## PLANNING REPORT

# Planning & Zoning Commission

## LIGHTBRIDGE ACADEMY 24-054FDP

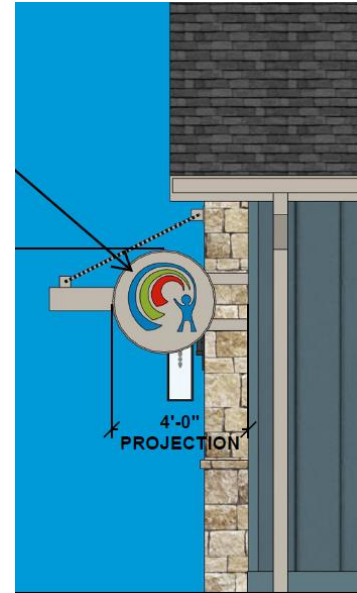
The applicant is proposing a dumpster enclosure south of the outdoor recreation area in the parking lot. The enclosure will be 7 feet – 4 inches in height and be clad in stone to match the building. Additional mechanical equipment is provided on the east side of the building and will be screened by a 3.5-foot tall cross buck fence.
